SERVICE BULLETIN

Classification: EL01-005a	Reference: NTB01-028a	Date: October 17, 2003
------------------------------	--------------------------	---------------------------

HEADLIGHT CONNECTOR REPLACEMENT

IMPORTANT: THIS BULLETIN HAS BEEN REVISED.

Diagnosis/Repair Flow Chart

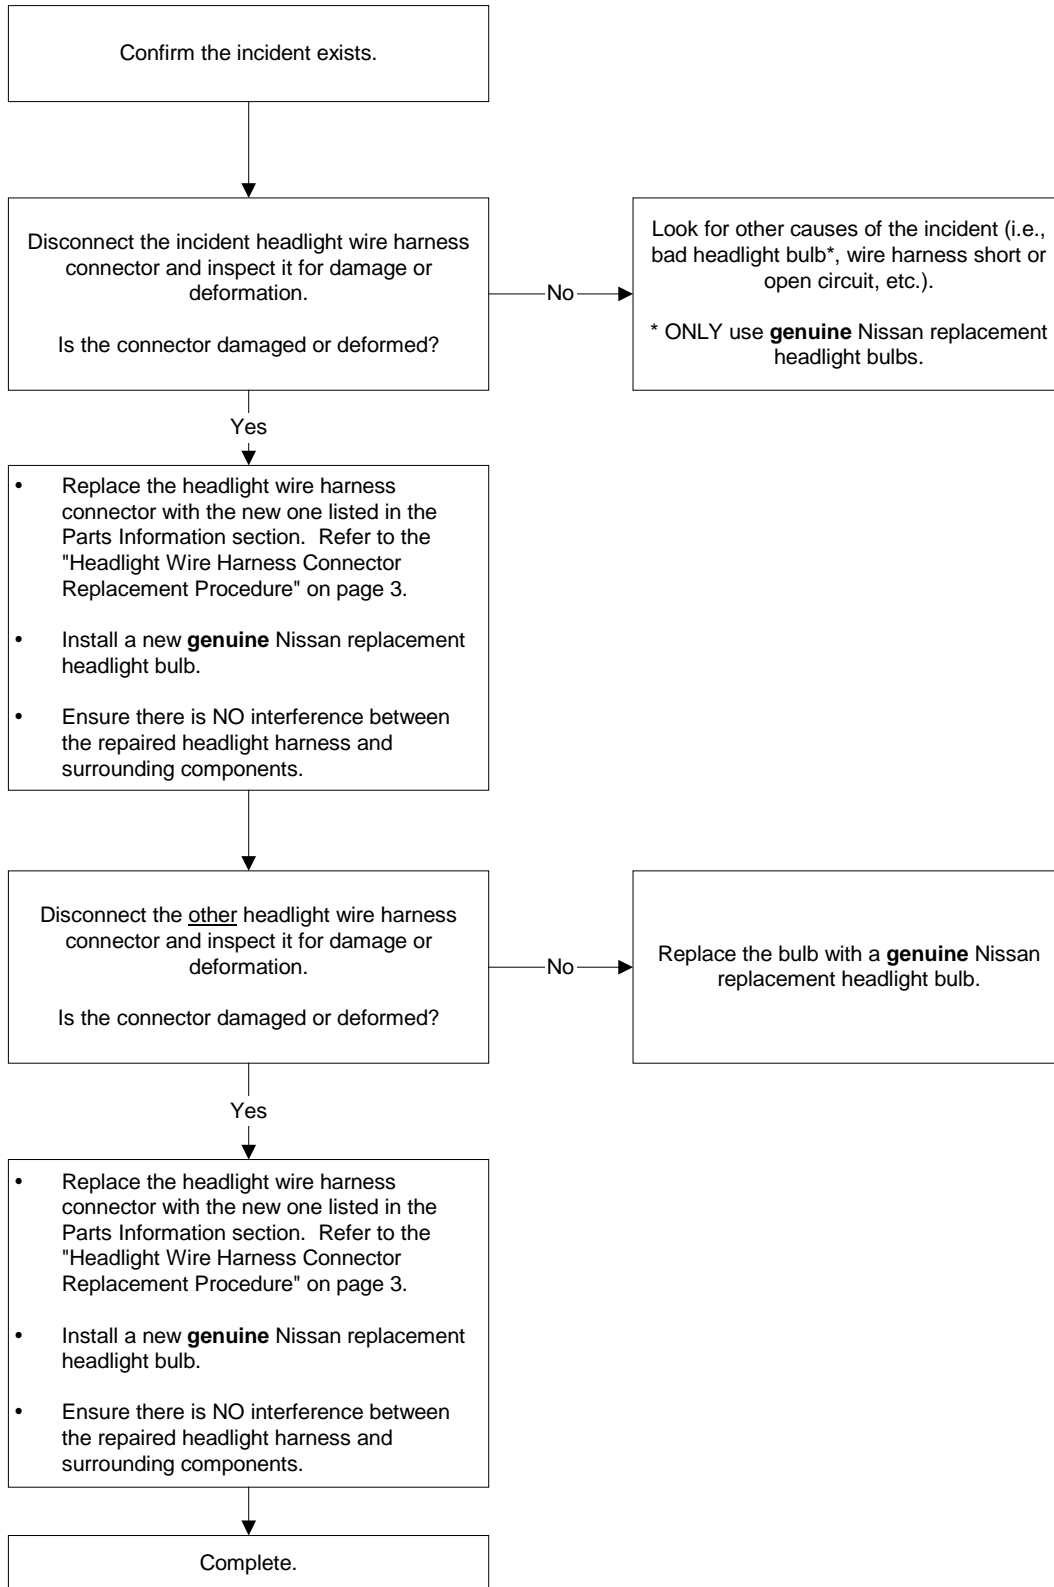
Refer to the “Diagnosis/Repair Flow Chart” on page two to diagnose and resolve this incident, should it occur.
